Title of Change:	Datasheet Package Drawing Correction Correct package Drawing for NCD9812 (update from CASE 485CT to CASE 485QT)
Effective date:	20 Nov 2019
Contact information:	Contact your local ON Semiconductor Sales Office or Ken.Chang@onsemi.com
Type of notification:	This Product Bulletin is for notification purposes only. ON Semiconductor will proceed with implementation of this change upon publication of this Product Bulletin.
Change Category:	Datasheet case drawing correction
Change Sub-Category(s):	Datasheet/Product Doc change

Package Drawing on the current datasheet. CASE 485CT

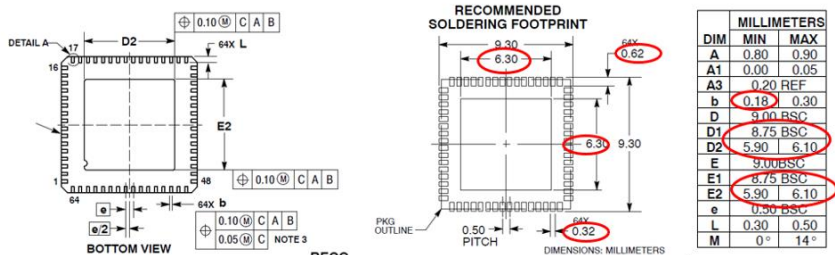
Incorrect Package Drawing was supplied and mentioned on the latest NDC9812 datasheet. This will be corrected to the right CASE drawing. All references and drawing for CASE 485CT will be updated to reflect CASE 485QT information instead. The change will not impact form, fit, or function of product(s).

Package Drawing to be corrected to CASE 485CQ
